**SITE PLAN: LOT 347, PHASE 4,
THE PARKE AT OCEAN PINES, SECTION 16,
THIRD TAX DISTRICT, WORCESTER COUNTY, MARYLAND**

SOULÉ & ASSOCIATES
ENGINEERING / SURVEYING / PLANNING
122 ARLINGTON ROAD
ARLINGTON BUSINESS CENTER
SALISBURY, MARYLAND 21801
(410) 742-7797

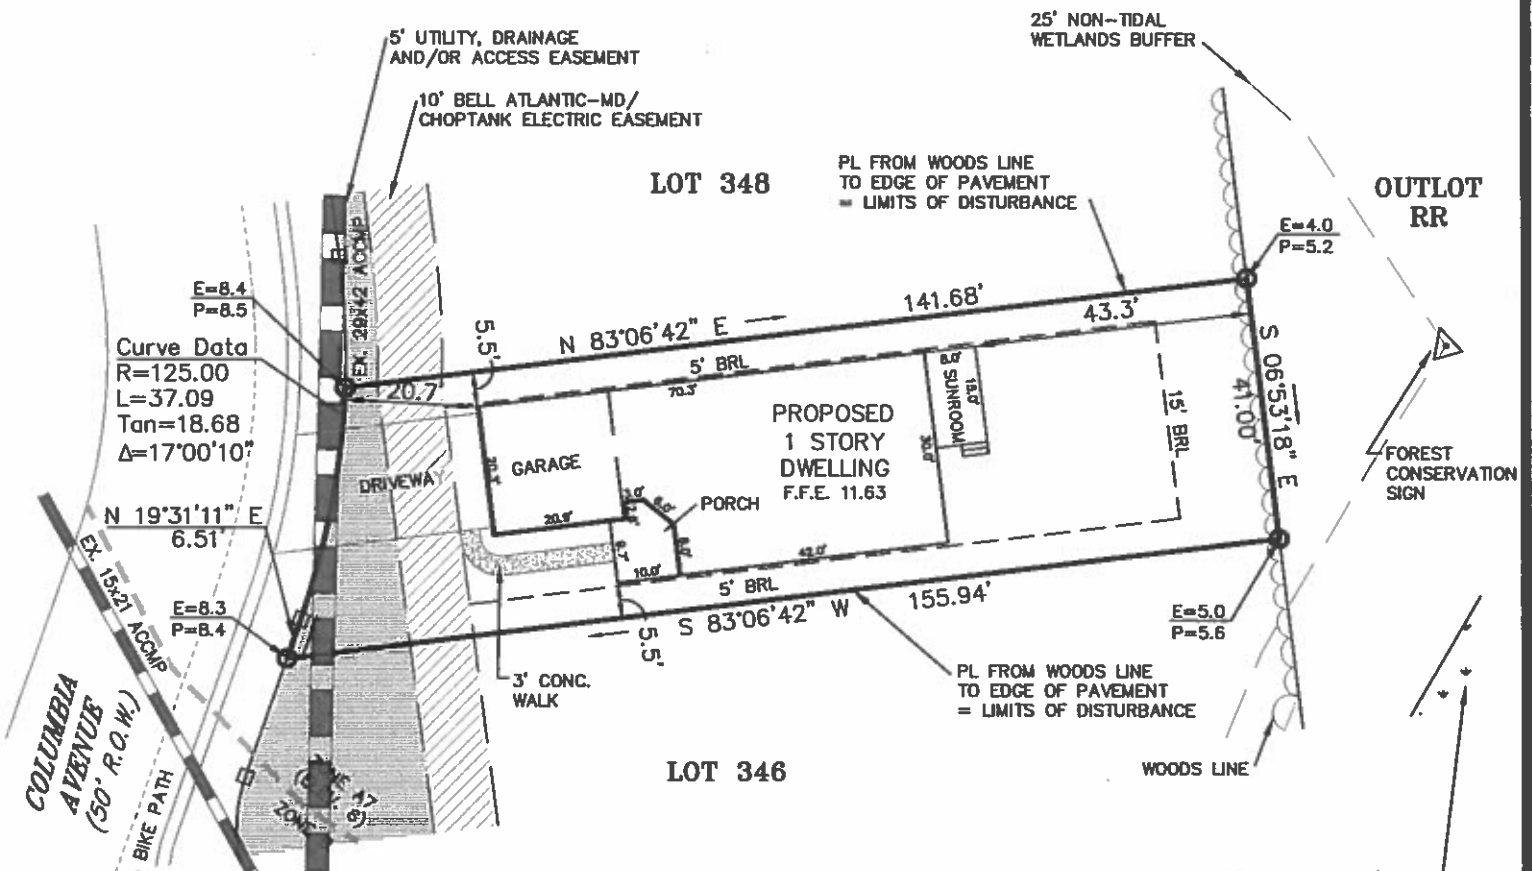
Comments: COM, SWM 83925
satisfies "90% rule"

John J. Davis
82903
B.P. 83924 SFD w/ SWM
garage, porch

Foundation location - As-Built required
